Subject: MHI's Responses to US-APWR DCD RAI No.300-2288

References: 1) "Request for Additional Information No.300-2288 Revision 1, SRP Section: 06.05.01 – ESF Atmosphere Cleanup Systems, Application Section: Tier 2 DCD 9.4.6" dated April 1, 2009.

Responses to Request for Additional Information No. 300-2288,
Revision 1

Figure 9.4.6-1 Containment Ventilation System Flow Diagram (2 of 2)

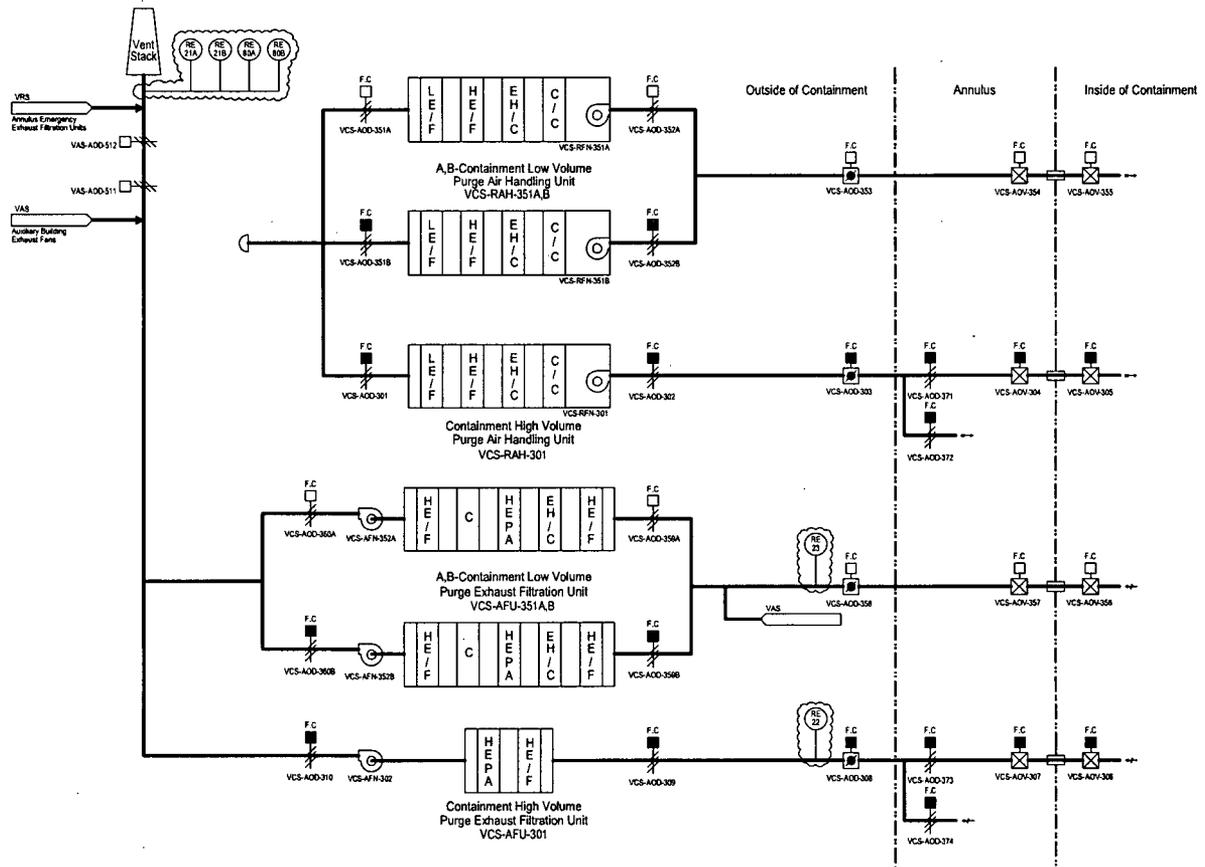
Figure 11.5-1b and Figure 9.4.6-1 collectively fail to allow the staff to determine where the "Containment Low Volume Purge Radiation Gas Monitor" (RMS-RE-23) is located within the Containment Purge Systems' HVAC system ductwork and with respect to the stack ventilation radiation monitors. Figure 9.4.6-1 should display both radiation monitors.

DCD Figure 9.4.6-1 "Containment Ventilation System Flow Diagram (2 of 2)" will be revised to show the following radiation monitors RMS-RE-22, 23 21A, 21B, 80A and 80B. This revision will clarify the relative position of the radiation monitors with respect to the ventilation system.

1. Revise DCD Figure 9.4.6-1 "Containment Ventilation System Flow Diagram (2 of 2)" per the attached mark-up drawing.
2. Revise DCD Subsection 11.5.2.2.2 "Containment Low Volume Purge Radiation Gas Monitor (RMS-RE-23)" second paragraph as follows:
